Access Compliance Report

Public Rights-of-Way

(Curb Ramps)

| Intersection ID: 28105 | Main Street: ELLINGTON PARK DR | Cross Street: OLIVIA LN | Location: NE |

| ADA ID: 3C110C3270B5 | Ramp Type: BlendTrans2 | Initial Pass/Fail: Fail | Overall Compliance: No |

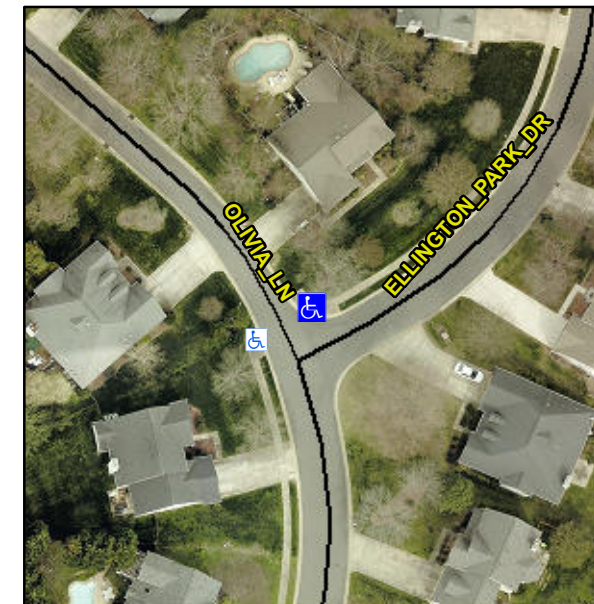
Not Found, R304.5.1

| Compliance | Description | Data | Compliance | Description | Data |
|------------|-----------------------|-------|------------|-----------------------------|-------|
| No | Ramp Width (in) | 31.0 | Yes | BlendTrans XSlope (%) | 0.8 |
| | | | No | Curb Slope (%) | 14.9 |

Remove & Replace Curb Ramp With Two New Directional Ramps or Equivalent.
